**Technical Bulletin 155**

# NGC Controller Module Interface Gasket Torque Specification Notice

Totalflow Technical Bulletin Version 1.0, Revision AC (8 October 2007)

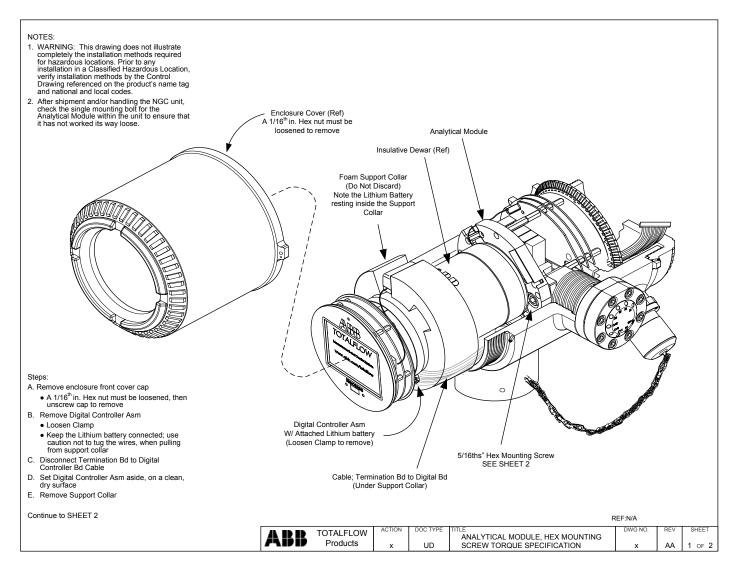
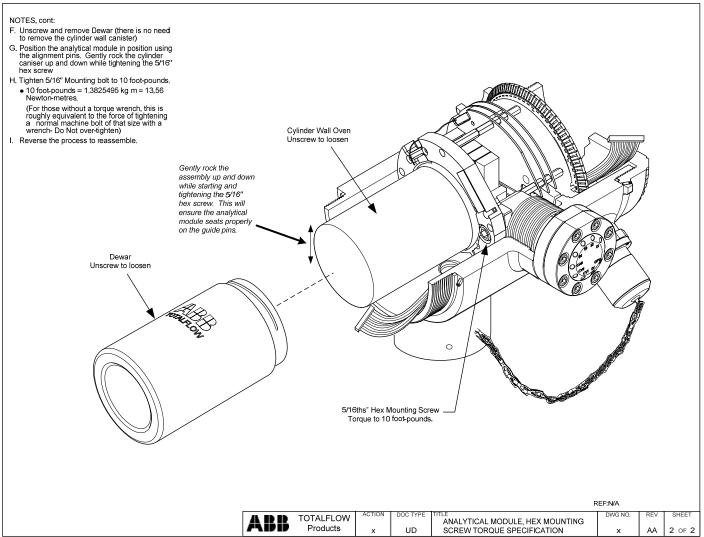
It has come to our attention that a small number of NGC-8206 gas chromatographs were found to have a small leak between the analytical module and feed through assembly. These leaks were due to the 5/16" hex head screw becoming loose during shipment.

**Note2:** As noted in the drawing above: Gently rock the assembly up and down while starting and tightening the 5/16" hex screw. This will ensure the analytical module seats properly on the guide pins.

ABB recommends this screw be tightened to either 10 ft/lbs or hand tight using a 5/16" hex head driver prior to startup or the next time a site visit is scheduled.

- 1. Place unit in hold mode
- 2. Collect all historical data
- 3. Save off configuration data using PCCU's save/restore utility (if not already backed up)
- 4. Remove power
- 5. Shut off stream, carrier and calibration valves to NGC feed through manifold
- 6. Continue by following the steps outlined in the two drawings below

**Note1:** If a torque wrench is not available then using the supplied hex head driver contained in the optional NGC tool kit (or customer supplied 5/16" hex wrench), take both hands and snug the hex head screw.
